From: s22
To: s22
Cc: s22 ; 's22' ; Blewett Richard; s22 ; "s22"
Subject: RE: CSIRO-Geoscience Australia Tranche 2 Report for the Carmichael Coal Project [DLM=For-Official-Use-Only] [SEC=UNCLASSIFIED]
Date: Friday, 22 February 2019 4:42:57 PM
Attachments: [image001.png](#)
[image002.png](#)
[image003.png](#)
[image004.png](#)
[image005.png](#)

From: s22 ga.gov.au]
Sent: Friday, 22 February 2019 3:58 PM
To: s22
Cc: s22 ; s22 t@csiro.au' ; Blewett Richard ; s22 ; s22 @csiro.au'
Subject: CSIRO-Geoscience Australia Tranche 2 Report for the Carmichael Coal Project [DLM=For-Official-Use-Only]

Dear s22
Attached is the joint CSIRO/GA submission for Tranche 2 of the DoEE advice request for Carmichael Coal Mine Project. Tranche 2 is a focused review of the draft groundwater management and monitoring plan and draft groundwater dependent ecosystem management plan provided by the proponent, looking at use of groundwater modelling and approaches to monitoring and management. This advice also includes Tranche 1 and pre-Tranche 2 reports. If the Department has specific questions regarding this submission, please contact s22 s22 @ga.gov.au) for further information.

Title : CSIRO-Geoscience Austr

Figure 1. Spatial distribution of off-lease monitoring bores. Note that some locations represent nested bore sites. The green polygon shows the Proponent's mining lease areas.

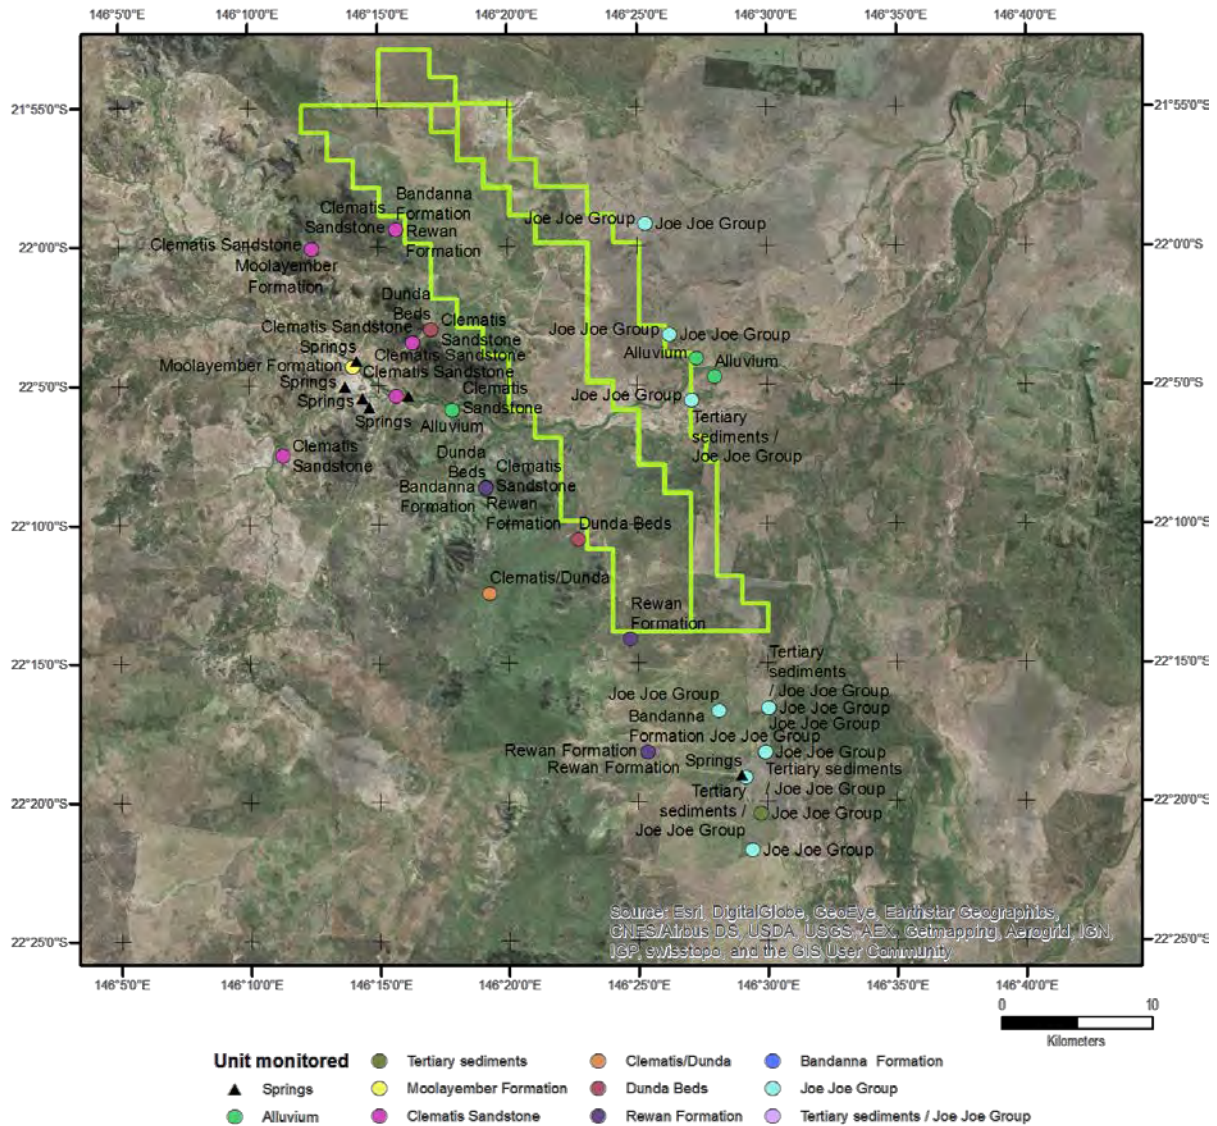
In the GMMP, there are 54 off-lease monitoring bores (Table 1 and Figure 1 below). The off-lease monitoring bores are primarily designed to monitor the Joe Joe Group and the Clematis Sandstone. These are the source aquifers proposed by the proponent for the Mellaluka Springs and DSC respectively. The monitoring network set out in the GMMP for the Mellaluka Springs appears adequate, given that these are sourced from the Joe Joe Group and Tertiary¹ sediments.
